# Central Planning Authority

**Agenda** for a meeting of the Central Planning Authority to be held on **8 May 2024 at 10:00am** in Conference Room 1038, 1st Floor, Government Administration Building, 133 Elgin Avenue

CPA/14/24

Figure 1: Land cover map overlaid on proposed site plan, note the majority of the site is covered by tidally flooded mangrove forest and woodland (Source: DoE, 2023)

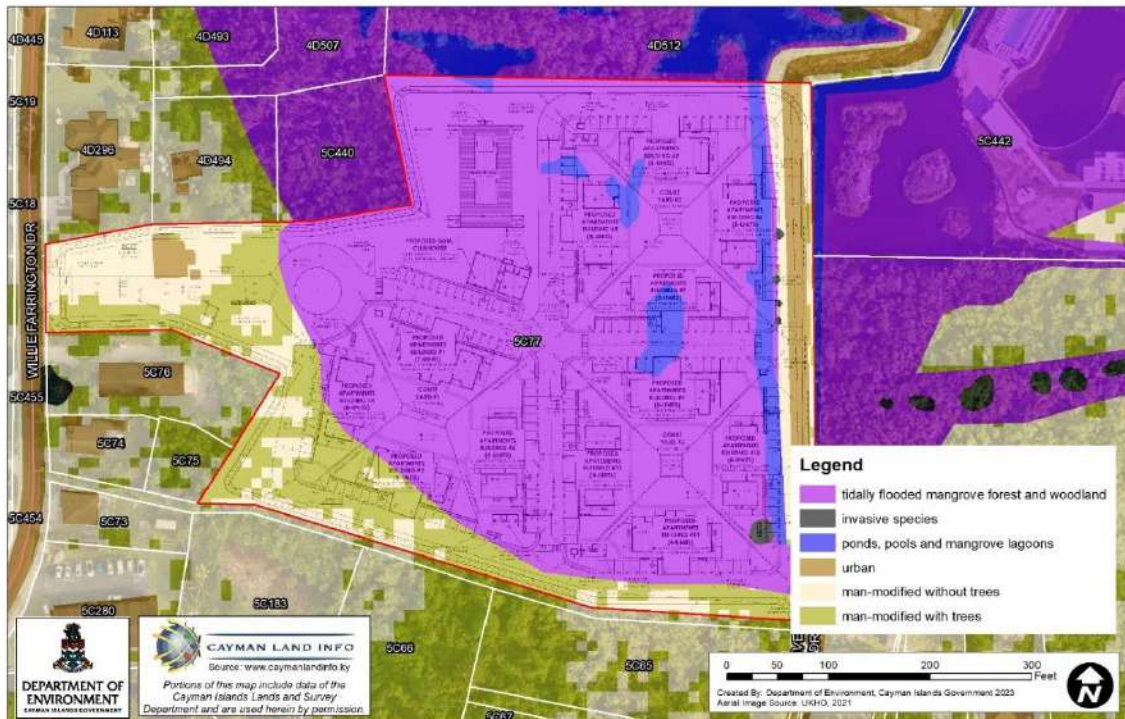
*The application site consists primarily of tidally flooded mangrove forest and woodland (refer to Figure 1) and features several ponds or pools.*

*Figure 2: Site contours overlaid on 2018 aerial imagery (Source: LIS, 2018)*

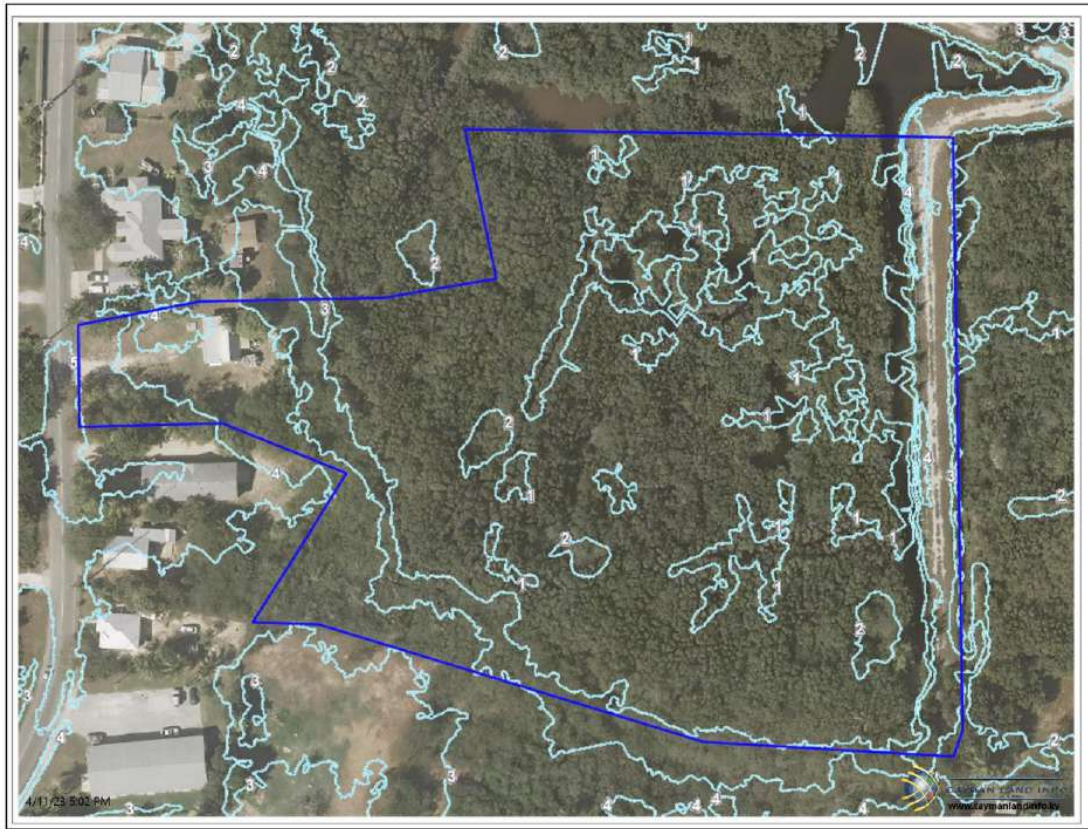
*The site is very low lying, averaging around 1 foot above Mean Sea Level (refer to Figure 2). As such, drainage is likely to be a significant concern. We are pleased to see that the revisions to the plan feature a number of areas that have been used to incorporate detention basins or retention ponds and the perimeter of the property features a swale. If incorporated effectively, these measures can be beneficial to the drainage of the site, as well as the surrounding area. We have not been provided with a comprehensive Stormwater Management Plan for detailed review, however we do support the inclusion of these aspects.*

*We further recommend that the applicant considers the use of porous or permeable paved surfaces in areas of hard standing such as the driveways and parking areas.*

Figure 1: Land cover map overlaid on proposed site plan, note the majority of the site is covered by tidally flooded mangrove forest and woodland (Source: DoE, 2023)

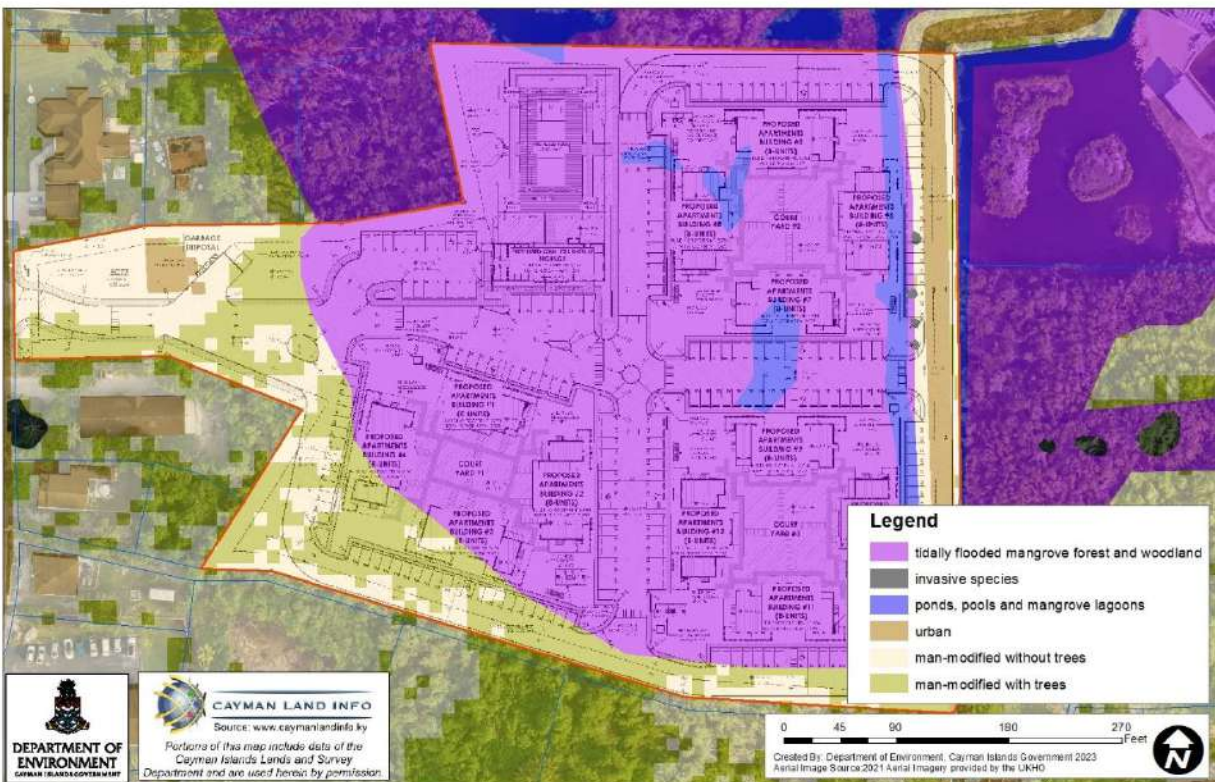
*The application site consists primarily of tidally flooded mangrove forest and woodland (refer to Figures 1 and 2) and features several ponds or pools.*

*Mangroves are Part 2 Schedule 1 protected species under the National Conservation Act (2013) with an adopted Mangrove Conservation Plan (2020). It is an offence to remove mangroves unless permission is explicitly sought to remove them either through a coastal works permit, planning permission or a National Conservation Council Section 20 permit.*

Figure 2: Site contours overlaid on 2018 aerial imagery (Source: LIS, 2018)

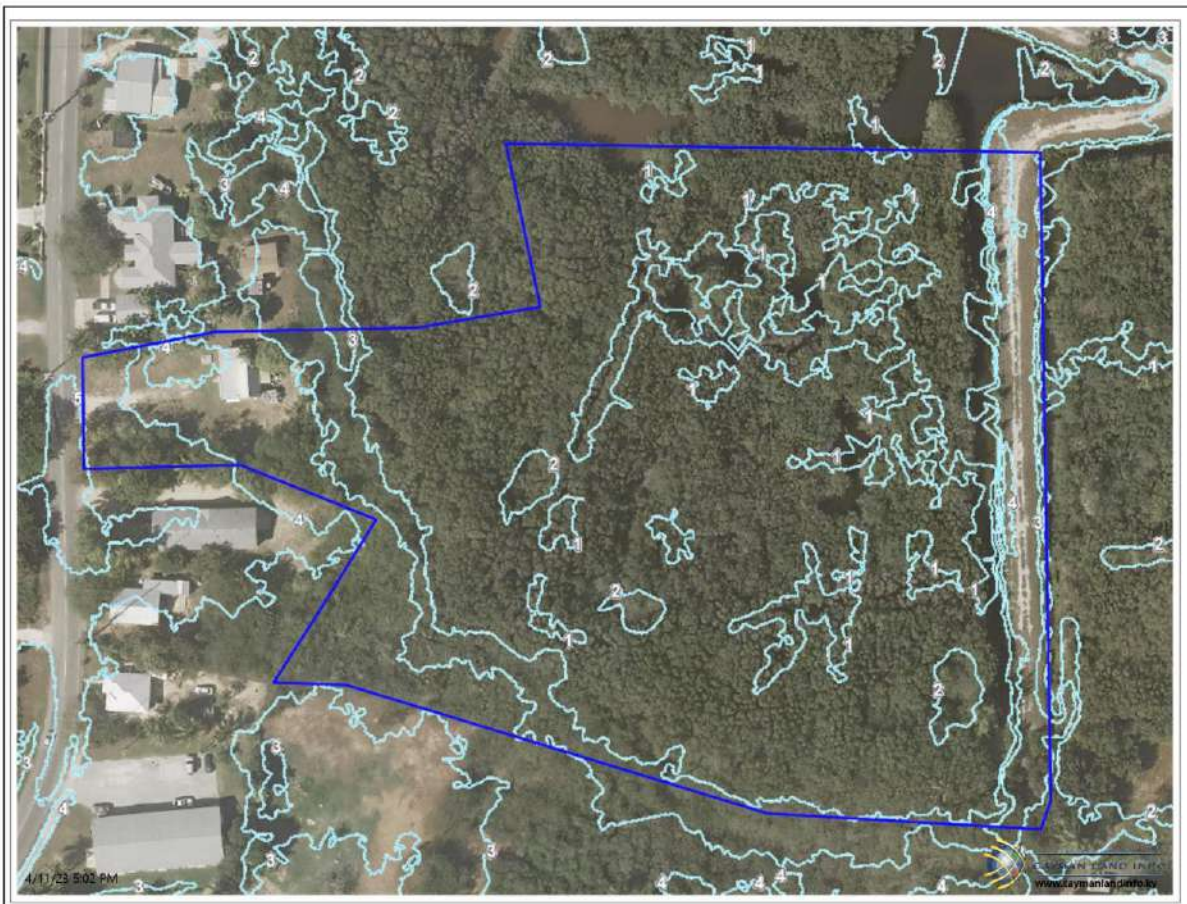
*The site is very low-lying, averaging around 1 foot above Mean Sea Level (refer to Figure 2). As such, drainage of the site and surrounding area is likely to be a significant concern.*

*We recommend that the applicant explores the use of porous or permeable paved surfaces in areas of hard standing such as the driveways and parking areas. The level of the site relative to the water table is likely to mean that commonly used drainage systems such as catch basins and deep wells are likely to be much less effective and may require additional maintenance over time to ensure they operate sufficiently. The proposed site plan features a number of courtyard areas which could be used to incorporate sustainable urban drainage systems (SUDS) such as detention basins or retention ponds. This would not only improve the drainage of the site but also the surrounding area. On-going maintenance of these areas will be important to maintain their effectiveness and prevent the breeding of pests such as mosquitos.*

Figure 2. The application site with the parcel boundary highlighted in red and the different types of vegetation found on the site (Aerial Imagery Source: UKHO, 2021 & Vegetation Data Source: DoE, 2013).

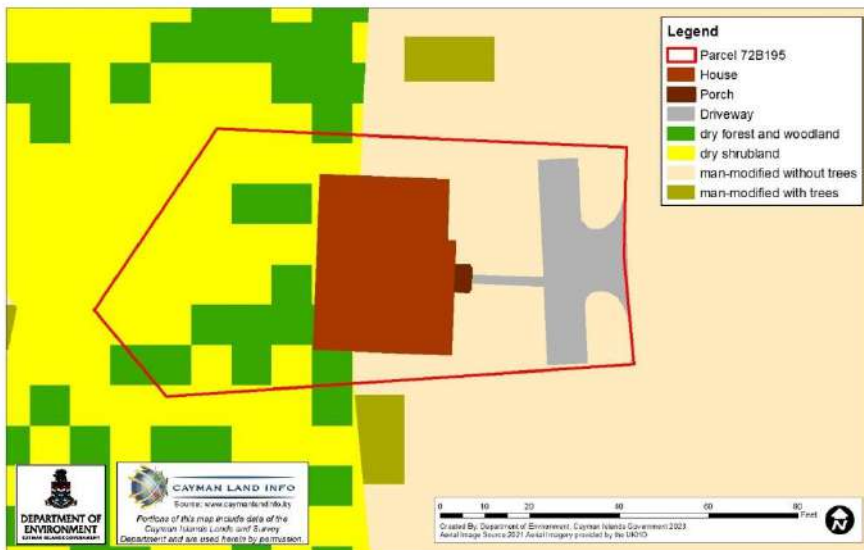
*As seen in Figures 1 and 2, the site is man-modified but the western half of the parcel contains primary habitat, namely dry shrubland and dry woodland. Primary habitat is mature habitat in its natural state, otherwise uninfluenced by human activity where ecological processes are not significantly disturbed. These habitats are often very old, existing long before humans and may consist of many endemic and ecologically important species. Primary habitat is in severe decline and becoming a scarce and highly threatened resource as a result of land conversion for human activities.*

*As seen in Figure 2, the applicant should retain as much native vegetation as possible and incorporate it into the landscaping scheme, particularly in the backyard area of the proposed house as it contains primary habitat. Primary habitat and native vegetation can be retained and used in a variety of ways on a property:*
